NEWS DA AIRCOM

NUOVI RACCORDI ENTRATA

NEW INLET FITTINGS

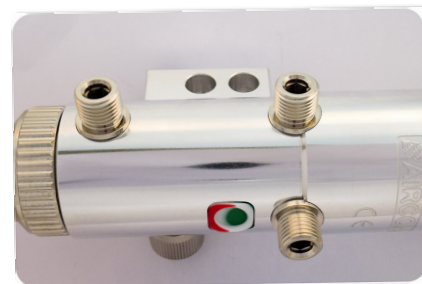
NUOVO

VECCHIO

NUOVO

A partire dalla settimana 28*12 tutte le pistole AIRCOM vengono consegnate con:

- il raccordo entrata aria comando (part. R1),
- il raccordo di entrata aria atomizzazione (part. R2),
- il raccordo di entrata pigmento (part. R3)

modificati nel loro disegno per trattenere meno sporco (accumulo di pigmento) e quindi avere un corpo pistola più pulito.

Rimangono invariati il materiale utilizzato (ottone) ed il rivestimento di Nichel.

N.B.: per smontare e/o rimontare i nuovi raccordi entrata utilizzare una chiave esagonale per interni DIN 911 da 6 mm.

MOD. DA

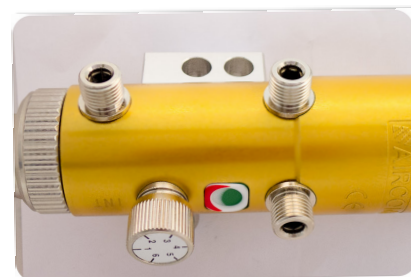
Starting from week 28 * 12 all AIRCOM spray guns are delivered with:

- the control air inlet fitting (item R1),
- the atomisation air inlet fitting (item R2),
- the pigment inlet fitting (item R3)

modified in their design to hold less dirt (accumulation of pigment) and thus have a cleaner gun body.

No changes have been made to the material used (brass) and the nickel coating.

N.B.: to remove and / or reassemble the new inlet fittings use an hexagonal key (DIN 911 6 mm.).
